Access Compliance Report Public Rights-of-Way (Curb Ramps)

Main Street: BELLEFORD_RD Cross Street: WICKSHIRE_LN Location: N

ADA ID: RPRK220103135240 Ramp Type: Type 1 - Perpendicular Diagonal Initial Pass/Fail: Pass Overall Compliance: No Severity Score: 16

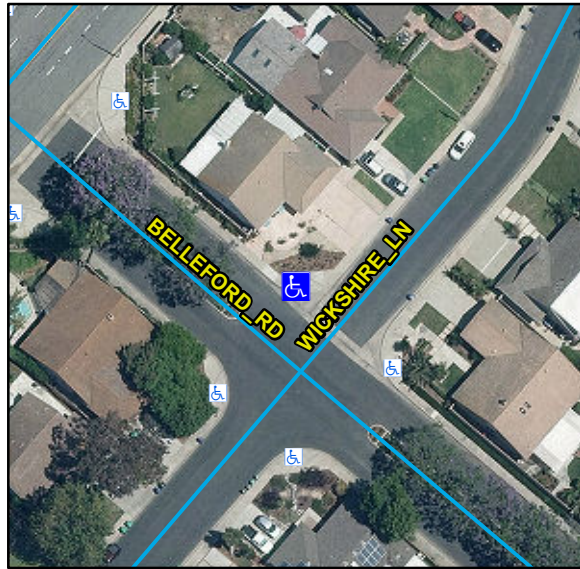
N/A	Ramp Inside Crosswalk 1	N/A	Yes	Ramp Inside Crosswalk 2	N/A
	Crossing 1 Slope (%)	4.1		Crossing 2 Slope (%)	1
	Crossing 1 Cross Slope (%)	0.3		Crossing 2 Cross Slope (%)	0.1
Yes	Gutter Ponding	No	Yes	Curb Slope	2.6
No	Gutter Lip Height (in)	0.25		Road Run Slope (%)	0.4
Yes	Gutter Run Slope (%)	0.1		Road Cross Slope (%)	0.2
Yes	Gutter Cross Slope (%)	0.2			
Yes	Overall Surface Condition: Acceptable		No	Perp Joint Present	No
	Cross Gutter Present?	Yes		Spandrel Present?	Yes
	Replace Cross Gutter?	No		Replace Spandrel?	No

Remove & Replace Curb Ramp With Two New Directional Ramps or Equivalent. Grind Gutter Lip.

R204.3, R304.2.1, R305, R302.7.2, STD 1115
